INDEX OF STRUCTURAL DRAWINGS

**KUHIO HIGHWAY SHORT-TERM
IMPROVEMENTS KUAMOO ROAD
TO TEMPORARY KAPAA BYPASS ROAD**
Fed. Aid Proj. No. NH-056-1(50)

"AS-BUILT"

**SECTION A**  
Scale: 3/4" = 1'-0"  
S1.2 S1.4

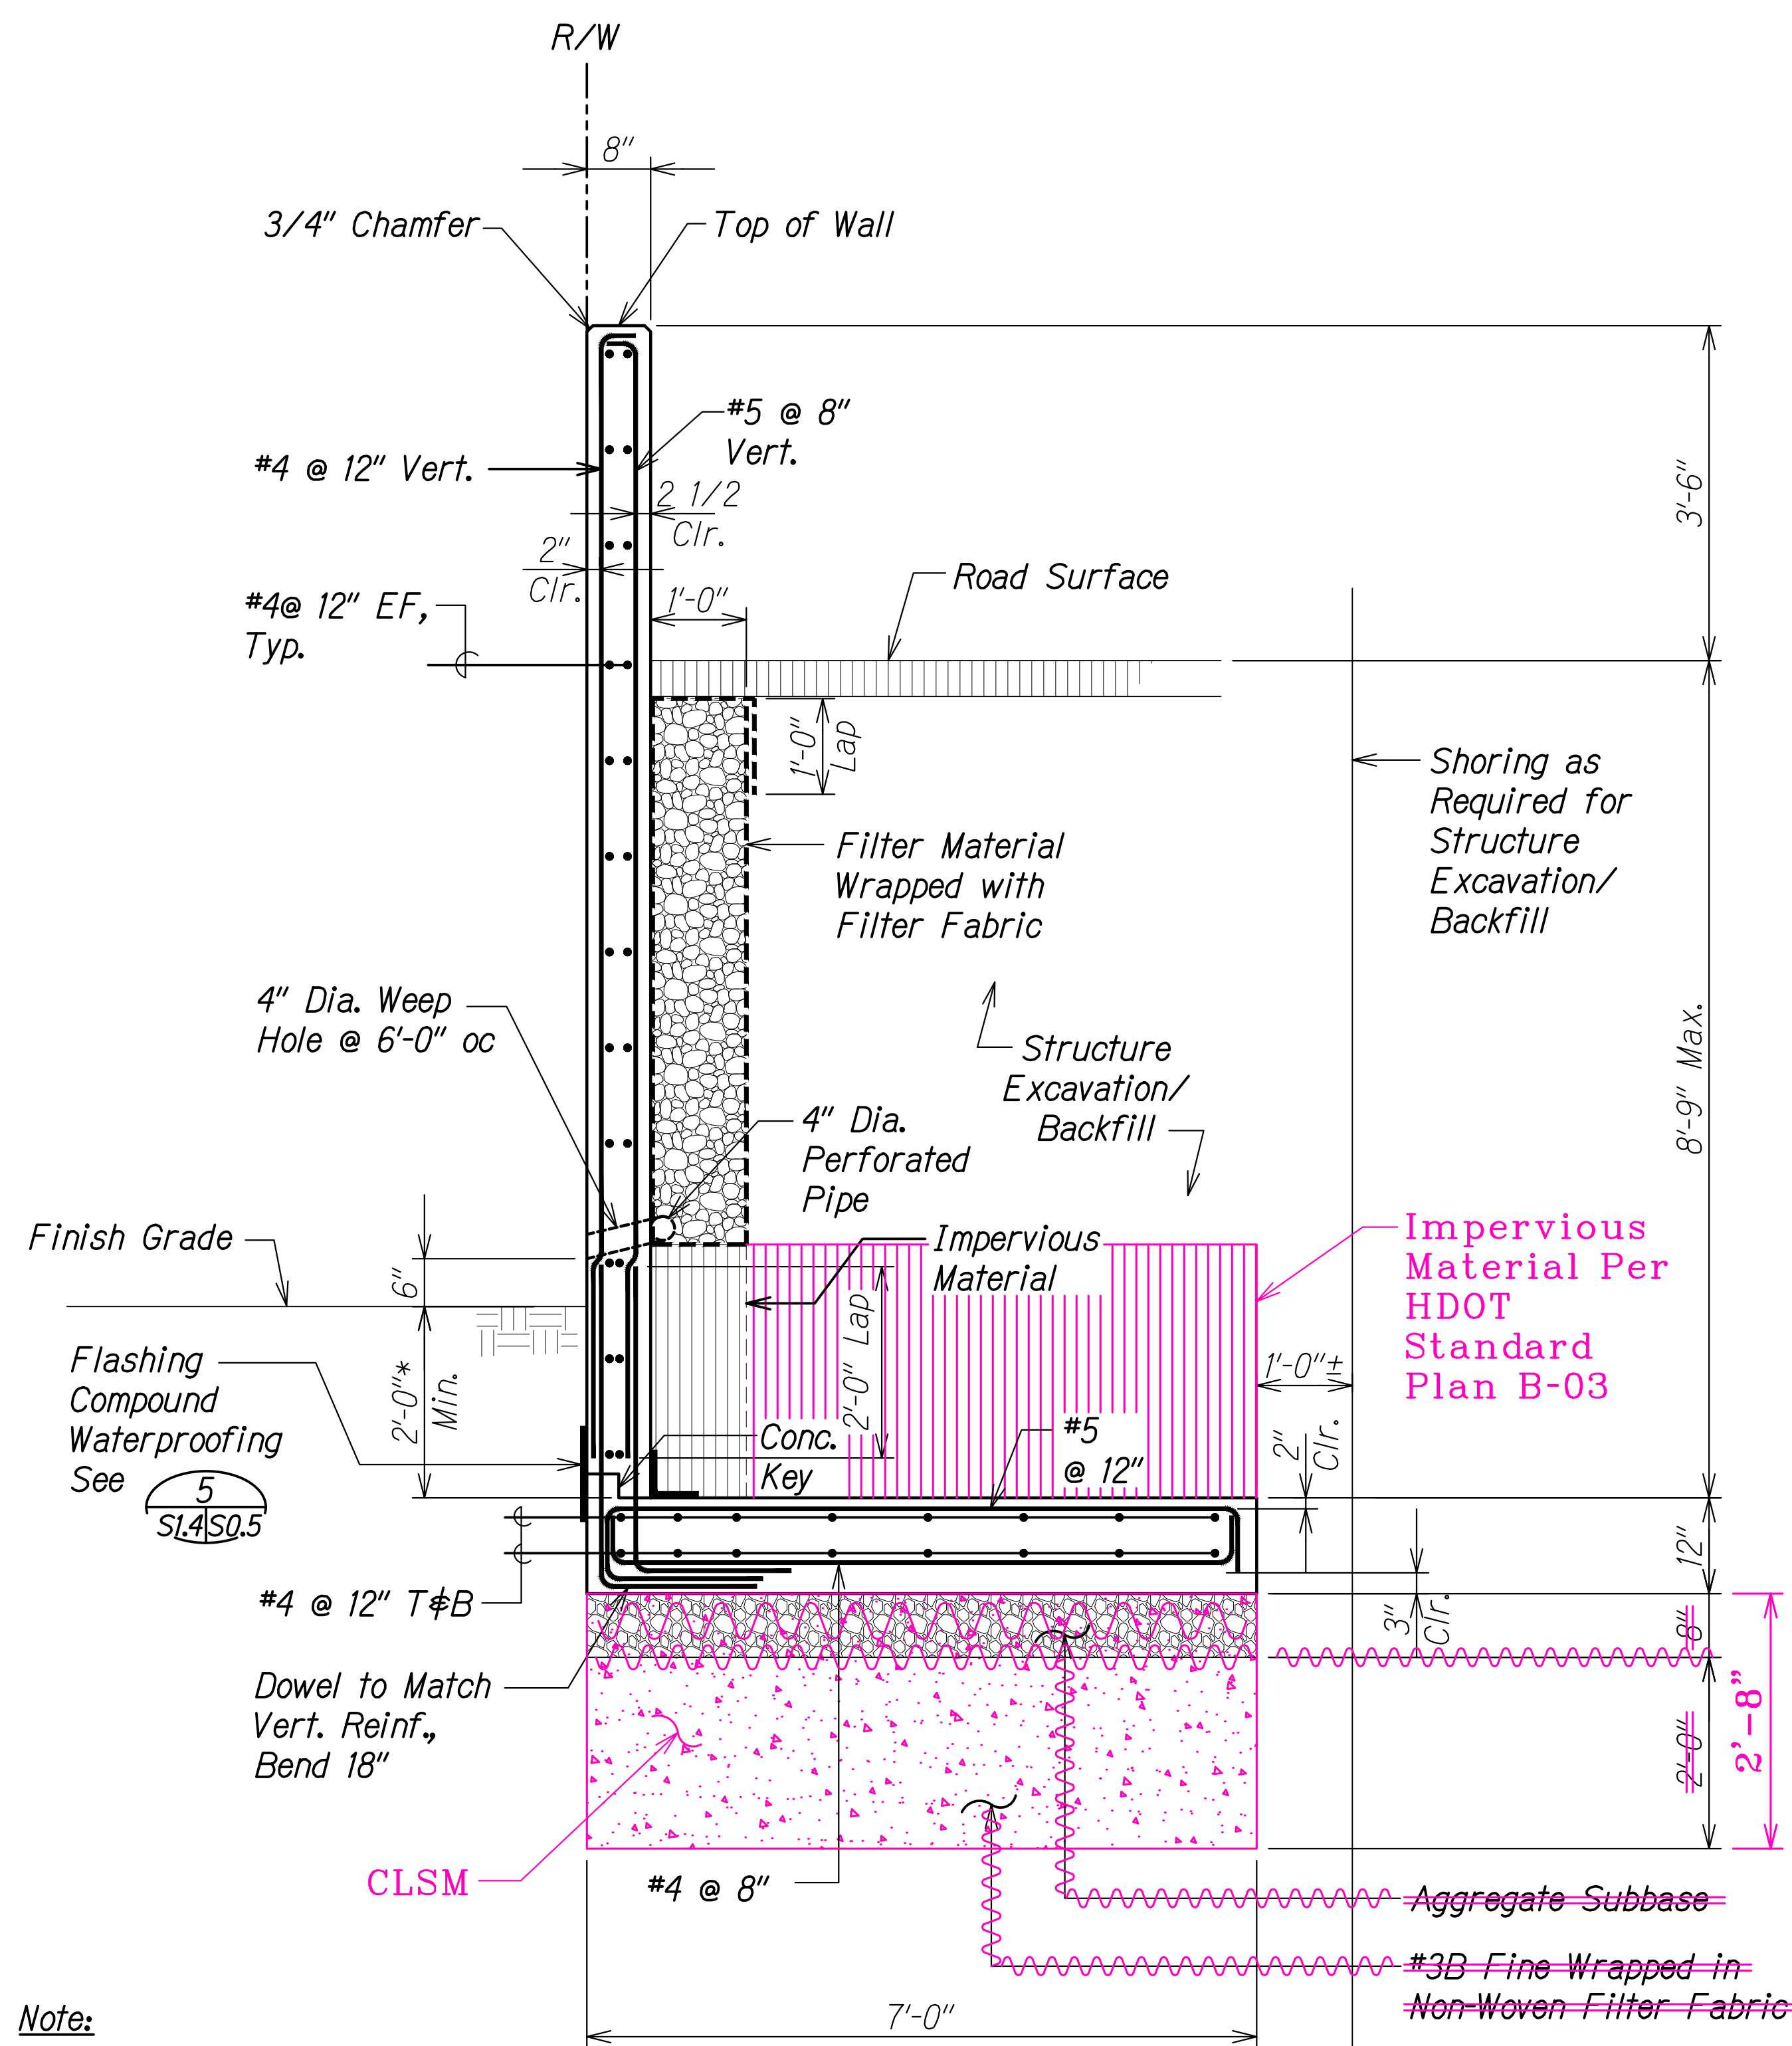
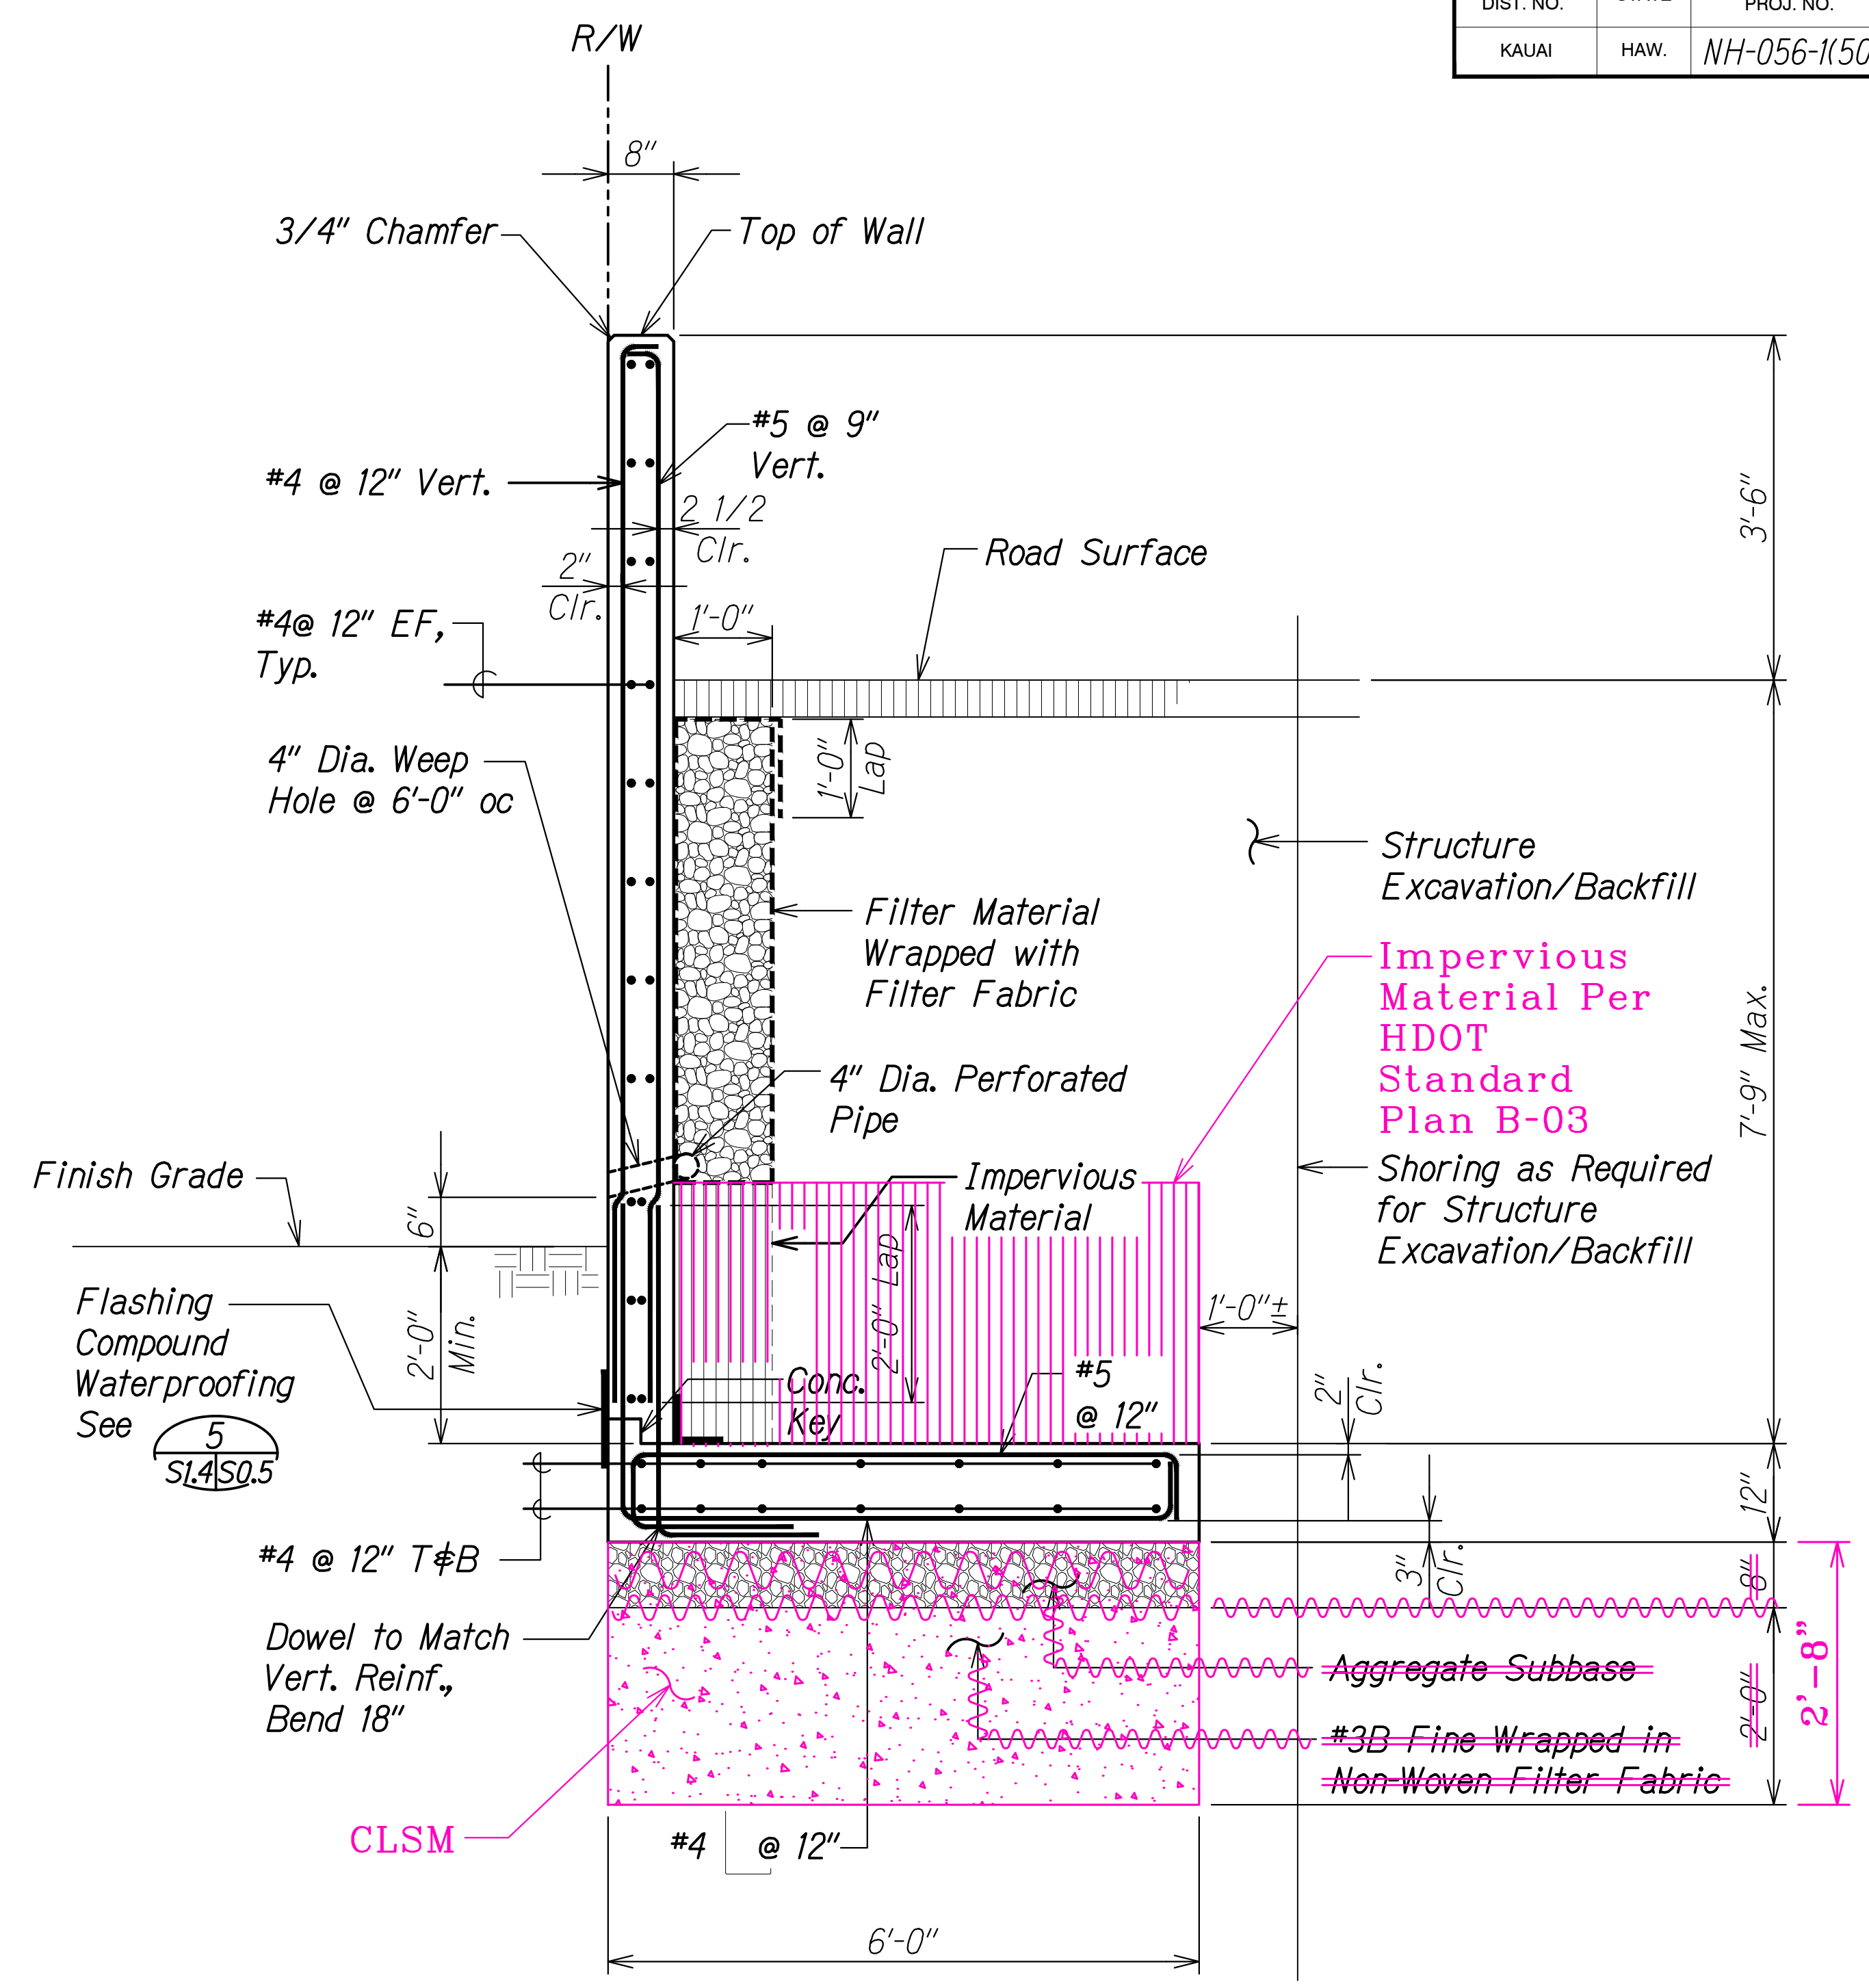
| DATE     | REVISION                                                                |
|----------|-------------------------------------------------------------------------|
| 7/5/21   | 5 C.O. Revised and new EB headwall sections.                            |
